#### ZONE CHANGE REVIEW SHEET

<u>CASE</u>: C814-88-0001.10 <u>Z. P. C. DATE</u>: 11/05/13, 11/19/13, 12/03/13

Canyons @ Rob Roy Rezoning

**ADDRESS**: 800 N. Capitol of Texas Highway **AREA**: 16.82 acres

LAND USE SUMMARY - DAVENPORT WEST 2.U.D.

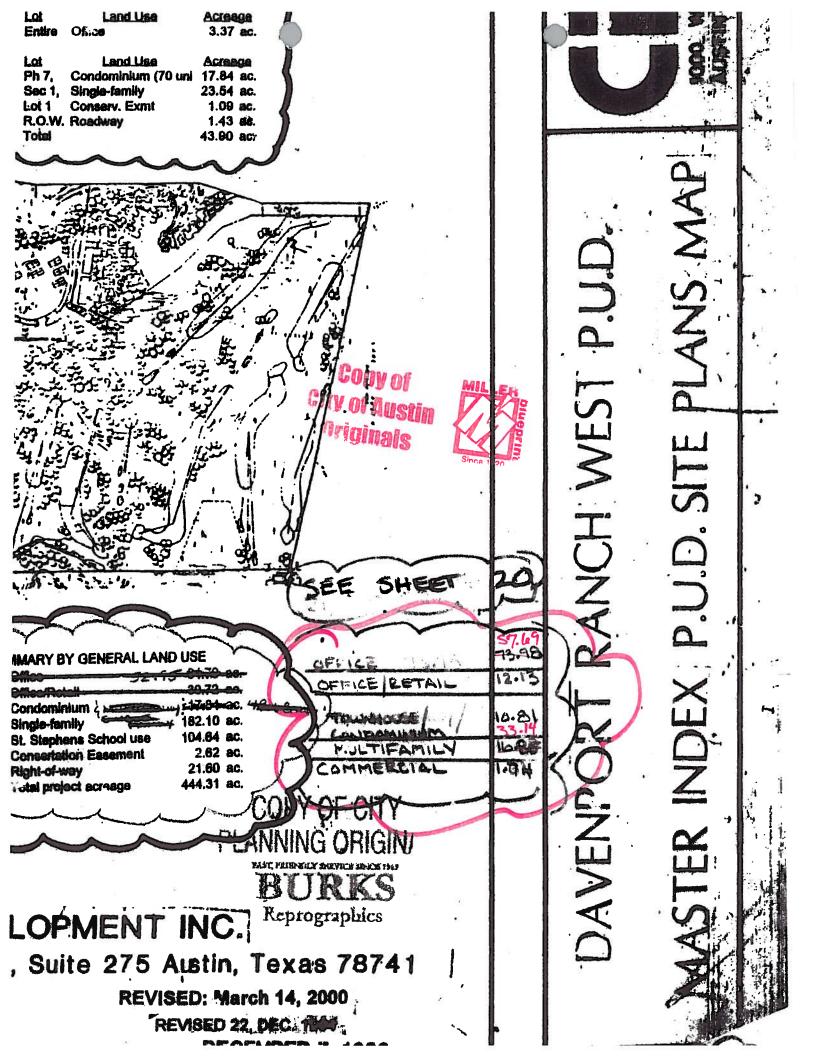
Exhibit "H" Land Use Plan. Change the Overall Summary by General Land Use Table on Sheet 1 to reflect a change from office use to multifamily use; adjust the acreages accordingly.

Exhibit "H" Land Use Plan. Change the Land Use Summary Table on Sheet 1 to reflect the correct lot and change the proposed land use from office to multifamily.

Justification. The Property was zoned for office use in 1988, since then it has remained undeveloped. West Austin lacks a sufficient supply of multifamily development for families looking to move to the area that otherwise might not be able to afford owning their own home. The few multifamily developments located in the surrounding area experience an occupancy rate of over 90%. Additionally, the proposed low density multifamily residential use provides a better transition between Capital Texas Highway located to the west and the residential uses located to the north and east of the site.

Justification. The Property was zoned for office use in 1988, since then it has remained undeveloped. West Austin lacks a sufficient supply of multifamily development for families looking to move to the area that otherwise might not be able to afford owning their own home. The few multifamily developments located in the surrounding area experience an occupancy rate of over 90%. Additionally, the proposed low density multifamily residential use provides a better transition between Capital Texas Highway located to the west and the residential uses located to the north and east of the site.

# OVERALL ORDINANCE INFORMATION

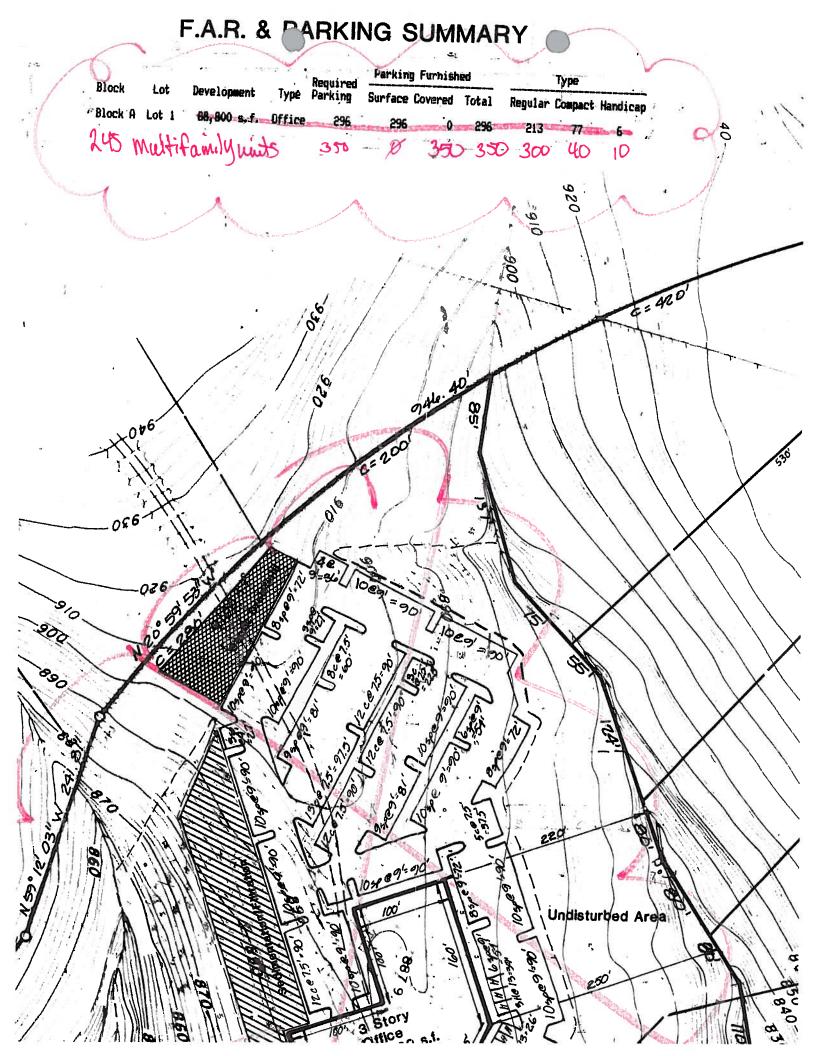
Exhibit "H" Land Use Plan. Clarify Ordinance Compliance Note #1 on Sheet 2 to read "Single family" residential areas are limited to a density of one unit per two acres of gross site area, with minimum one acre lots."

Exhibit "H" Land Use Plan. Change the Hill County Roadway Ordinance Calculations on Sheet 2 to deduct the site area calculations of Lot A-1.

Exhibit "H" Land Use Plan. Change the F.A.R & Parking Summary Table on Sheet 2 to reflect Lot A-1 as a multifamily project.

Exhibit "H" Land Use Plan. Change the diagram on Sheet 2 for Lot A-1 from "LO" to "MF-2".

Justification. As supported by Section 1.04 of the Restrictive Covenant recorded in Volume 10909, Page 1601 of the Real Property Records of Travis County, Texas for the Davenport Ranch West Planned Unit Development Section One, this restriction was intended to apply solely to single family residential development. I have attached a copy of the Restrictive Covenant for your reference with the companion Restrictive Covenant Amendment case.

Justification. Per the Hill County Roadway Ordinance the floor to area limitations only apply to nonresidential buildings.

Justification. The parking table only provides parking calculations associated with the office development on Tract D. Since the use is changing from office to multifamily we have updated the table accordingly.

Justification. The Property was zoned for office use in 1988, since then it has remained undeveloped. West Austin lacks a sufficient supply of multifamily development for families looking to move to the area that otherwise might not be able to afford owning their own home. The few multifamily developments located in the surrounding area experience an occupancy rate of over 90%. Additionally, the proposed low density multifamily residential use provides a better transition between Capital Texas Highway located to the west and the residential uses located to the north and east of the site.

# ORDINANCE CALCULATION SUMMARY

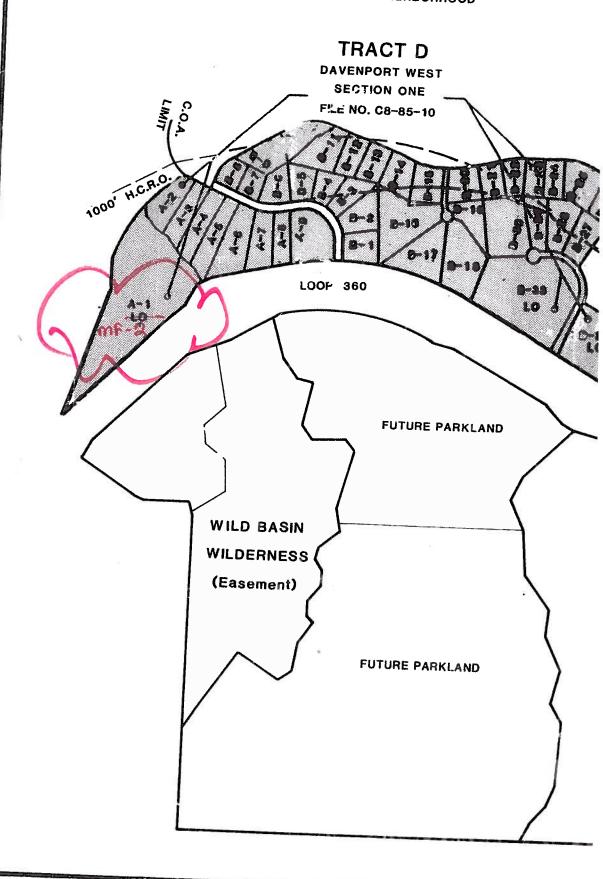
Exhibit "H" Land Use Plan. Remove the floor to area multiplier calculations and the allowable square footage calculations on Sheet 3.

Exhibit "H" Land Use Plan. Change the proposed impervious cover from 3.16 acres to 3.50 acres.

Exhibit "H" Land Use Plan. Change the Impervious Cover Summary Table on Sheet 3 to reflect the proposed impervious cover and to account for a different building configuration and parking layout.

Exhibit "H". Land Use Plan. Remove the Hill County Roadway Ordinance Table on Sheet 3.

Exhibit "H" Land Use Plan. Change the Comprehensive Watershed Ordinance Table on Sheet 3 to reflect the proposed impervious cover.

Exhibit "H" Land Use Plan. Remove the diagram on Sheet 3 of the office project.

Exhibit "H" Land Use Plan. Add a note on Sheet 3 that clarifies the maximum height allowed on Lot A-1 is 35 feet.

Exhibit "H" Land Use Plan. Remove the note on Sheet 3 that reads "Due to the pitch of the roof design and height limitations the square footage of the third story of this building will be reduced by approximately 50% from the first two stories.

Justification. Per the Hill County Roadway Ordinance the floor to area limitations only apply to nonresidential buildings.

Justification. While the proposed impervious cover is slightly more than the previous office project, this project is still under the 3.52 acres of impervious cover allowed for Lot A-1.

Justification. While the proposed impervious cover is slightly more than the previous office project, this project is still under the 3.52 acres of impervious cover allowed for Lot A-1. The prior office project proposed a vast amount of surface parking with a small building footprint. Since the use of the site is changing from office to multifamily the size and configuration of the building and parking area must also change to accommodate a more user friendly development. The proposal is to provide a wrapped product type with structured parking within.

Justification. Per the Hill County Roadway Ordinance the floor to area limitations only apply to nonresidential buildings.

Justification. While the proposed impervious cover is slightly more than the previous office project, this project is still under the 3.52 acres of impervious cover allowed for Lot A-1.

Justification. Zoning is used to establish the best use for a site and should not be used to dictate the location of site improvements. This should be deferred to the site development stage when engineered documents and related reports are available to assess the proper location of improvements based on site constraints. Also by removing the diagram from the land use plan it prevents future amendments to the PUD should the location of the site improvements fluctuate slightly.

Justification. There is no change from the previous proposal.

Justification. This note is unnecessary since the building is limited to 35 feet with height limit exceptions, as prescribed by 25-2-531 of the City Code, for certain architectural elements including pitched roof designs.
